Point Beach Nuclear Plant Units 1 and 2
Docket No. 50-266 and 50-301
Renewed License No. DPR-24 and DPR-27

Core Operating Limits Report (COLR) Unit 2 Cycle 35 (U2C35)
and Correction to Unit 1 Cycle 36 (U1C36)

**CORE OPERATING LIMITS REPORT (COLR)
UNIT 1 CYCLE 36 (U1C36)
(Revision 17)**

FIGURE 2
REQUIRED SHUTDOWN MARGIN

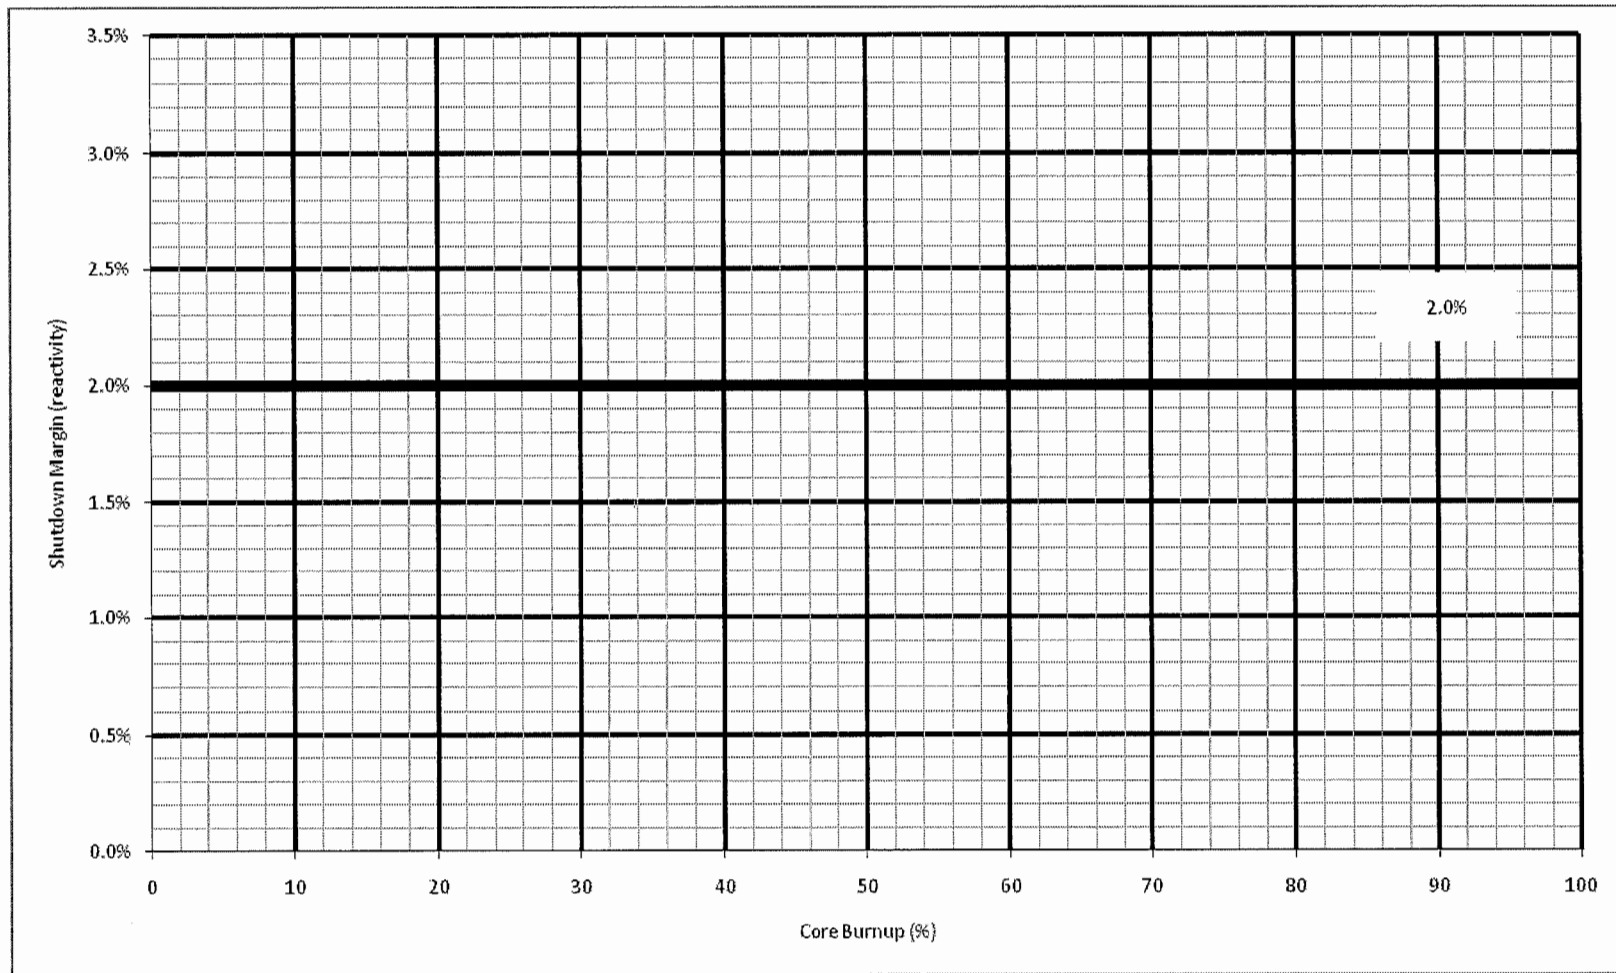
Enclosure 1 to this letter contains the PBNP U2C35 COLR that was issued on October 15, 2015. Enclosure 2 to this letter contains a revised U1C36 COLR to correct Figure 2. It was identified that the numeric values in Figure 2 did not display properly.
